## OROTEX BUILDING ADDITION JSP17-85

Approval at the request of Orotex for Preliminary Site Plan, Landbank Parking and Storm Water Management plan approval. The subject property (22475 Venture Drive) contains 5.96 acres and is located in Section 26, on the west side of Venture Drive and north of Nine Mile Road, in the I-1, Light Industrial District. The applicant is proposing a 60,000 square foot addition to the north end of the existing building with associated site improvements.

## PLANNING REVIEW

**Review Date:** January 12, 2018  
**Review Type:** Preliminary Site Plan  
**Project Name:** Orotex Building Addition  
**Plan Date:** 12-15-17  
**Prepared by:** Lindsay Bell, Planner  
**E-mail:** [lbell@cityofnovi.org](mailto:lbell@cityofnovi.org) **Phone:** 248.347.0484

ORIGINAL ISSUE DATE: DECEMBER 15, 2017  
PEA JOB NO. 2017-410  
SCALE: 1"=40'  
DRAWING NUMBER: **SP-2.0**

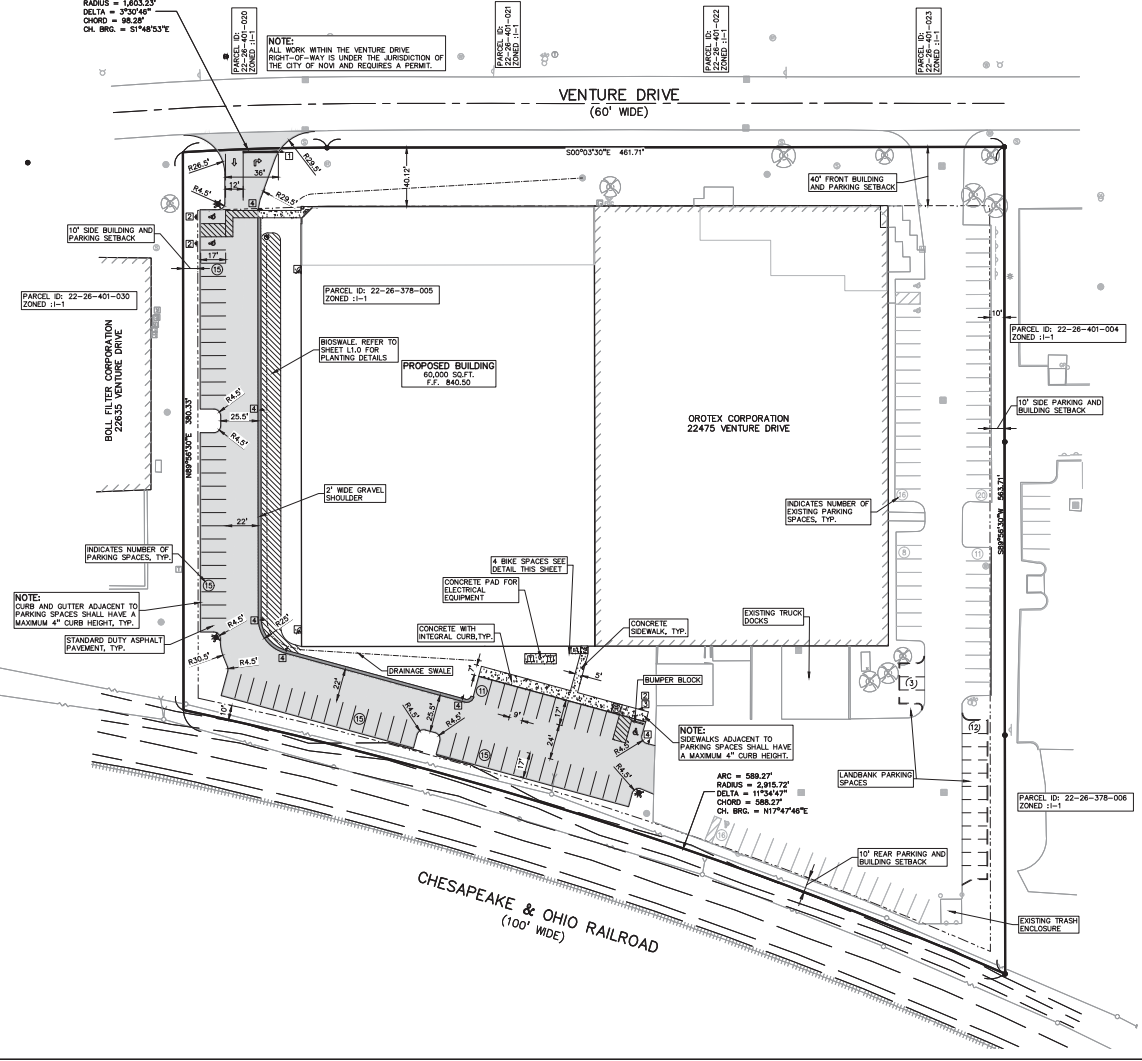
4. Response Letter: **Please provide a response letter addressing all comments and refer to sheet numbers where the change is reflected.**
5. Drive Aisles (Sec 5.3.2): **When adjacent parking spaces are present, drives aisles should be 24 feet. Several locations shown 22 foot drive aisles.**

11. Provide a separate plan for landbanked parking layout and grading.
12. Parking lot curb is required. Provide a curb along the south edge of the parking lot, with curb openings to allow flow into the bioswale area.
13. Provide top of curb/walk and pavement/gutter grades to indicate height of curb adjacent to parking stalls or drive areas.
  - a. Indicate standard 6 inch curb height at landscape islands and drive aisles.

- b. Include a curb height transition detail.
- 14. Revise grading plan to be consistent with the revised layout of accessible parking spaces.
- 15. The driveway width and layout are not in accordance with City standards. Refer to the traffic review letter for additional information.

- 16. The grade of the drive approach shall not exceed 2-percent within the first 25 feet of the intersection. Provide spot grades as necessary to establish this grade.

ORIGINAL ISSUE DATE: DECEMBER 11, 2011  
 PEA JOB NO. 2014-010  
 DRAWING NUMBER: L-010

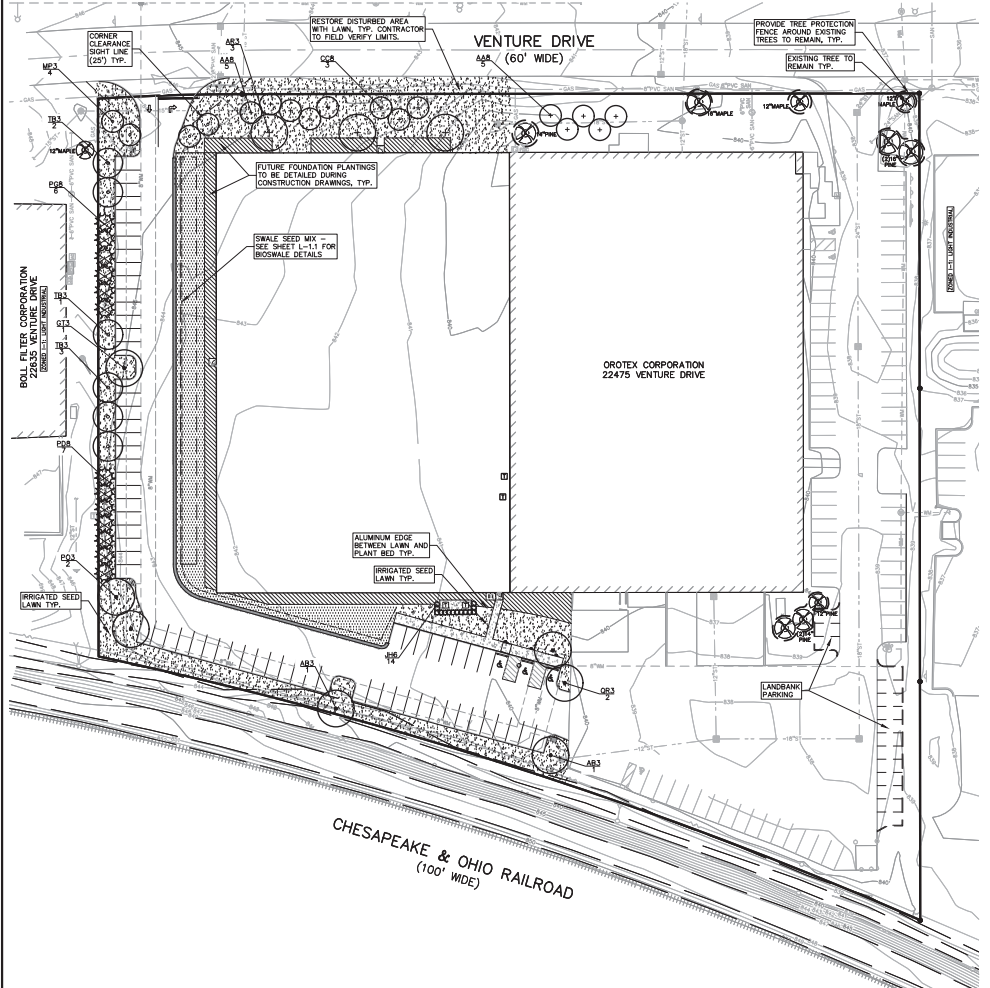
1. Provided.
2. There are overhead utility lines along the west property line.
3. **Please relocate the proposed water main so the required parking lot trees can be planted within the islands.**

1. No existing trees will be removed as part of this project.
2. **Please copy the tree fencing shown around existing trees near the addition shown on the landscape plan to the Grading Plan.**

1. The parking lot perimeter is actually 1190lf, not 805 lf. All parking lot areas at least 20 feet away from the building should be included in the calculation.
2. **Please provide the 34 required perimeter trees along all sides of the parking lot, not just the northern edge. They should be spaced evenly around the lot to help shade it.**
3. **On the west edge, where there are overhead lines, subcanopy trees can be used in place of the canopy trees at a rate of 1.5 trees per canopy trees, or 2 trees per canopy trees if a fastigiata variety is used.**
4. **Please see the landscape chart for other details related to the perimeter trees.**

<b>Sealed by LA.</b> (LDM 2.g.)	Requires original signature	Yes	Yes	<u>Need for Final Site Plans</u>
<b>Miss Dig Note</b> (800) 482-7171 (LDM.3.a.(8))	Show on all plan sheets	Yes	Yes	
<b>Zoning</b> (LDM 2.f.)	Include all adjacent zoning	<u>Parcel:</u> I-1 <u>North South, East,</u> <u>West:</u> I-1	Yes	
<b>Survey information</b> (LDM 2.c.)	<ul style="list-style-type: none"> <li>▪ Legal description or boundary line survey</li> <li>▪ Existing topography</li> </ul>	Topo, description on Sheet SP-1.0	Yes	
<b>Existing plant material</b> <b>Existing woodlands or wetlands</b>	<ul style="list-style-type: none"> <li>▪ Show location type and size. Label to be saved or removed.</li> </ul>	<ul style="list-style-type: none"> <li>▪ On Sheet SP-1.0.</li> <li>▪ All trees on site will be saved.</li> </ul>	Yes	<b>Please copy tree fencing shown on L-1.0 to sheet SP3.0</b>

Noted. When foundation plantings are detailed during construction drawings, foundation plantings will be shown in detail at 1" = 20'.
